Town of Marlborough Planning Board Transmittal

MEMORANDUM

RE: Twin Pond Enterprises, Inc. AKA Mannese Trucking Our file #8399

The following information is submitted to the Town of Marlborough Planning Board for review and consideration in connection with the application of Twin Pond Enterprises, Inc. (doing business as Mannese Trucking & Valley Pallet Recyclers) for a Wholesale storage establishment and are in response to the comments received from the Town of Marlborough Planning Board and Technical Review Comments from McGoey, Hauser, and Edsall dated March 29, 2018:

Eight Foot High
Solid Board Fence

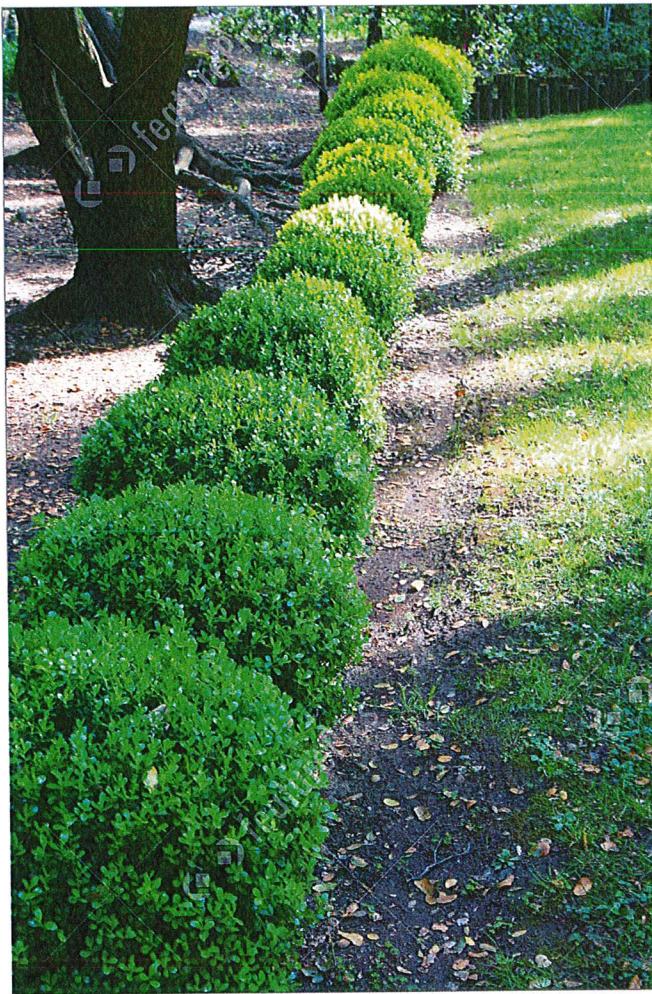
8. A photograph of the fencing is included with this submission. The current fencing will be extended as shown on the plan.
9. See items 7. And 8. above.

View from Route 9W
Screened Outdoor Storage
